**STAFF REPORT:** SEPTEMBER 9, 2020 MEETING PREPARED BY: B. CAGNEY

APPLICATION NUMBER: 20-6830 ADDRESS: 3711 WOODWARD

**HISTORIC DISTRICT:** ORCHESTRA HALL

**PROPERTY OWNER:** DETROIT SYMPHONY ORCHESTRA / LINDA LUTZ, CFO **SCOPE OF WORK:** INSTALL DIGITAL MONITORS IN EXISTING POSTER FRAMES

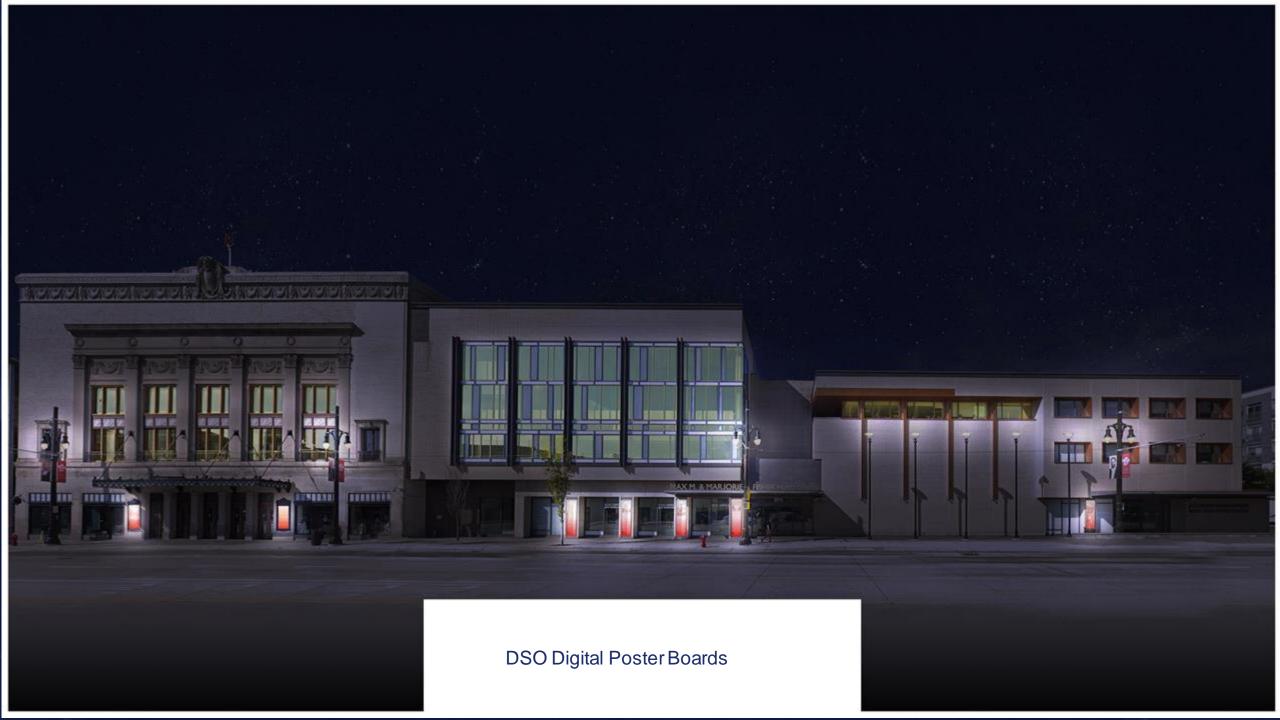
Bluewater understands that the frame of the poster is required to stay in place due to the Historical Designation of Orchestra Hall. The glass front measures 2'-117/8'' wide by 5'-67/8'' high. The current depth of the poster frame is 1'-5/8'' from the inside of the glass to the plywood.

The LED display is 2.83-feet wide by 5.67-feet high. The depth of the LED display with mounting channel is 2.12" deep.

Due to the shallow depth of the frame, the brick and other blocking in the rear of the poster frame will need to be removed to provide enough depth to mount and properly ventilate the LED display.

The rear plywood backing will be removed, the bricks behind the plywood will be removed and a new ¾" sheet of plywood will be attached to the inside structure to support the LED. No changes to the outside of the poster frame, existing glass or stone structure will be modified in any way. The LED display will be located totally within the current frame. The removal of the backing, brick and attaching the new plywood is the responsibility of the Detroit Symphony Orchestra. Bluewater will work with the DSO's contractors to ensure proper fit and ventilation for the LED displays.
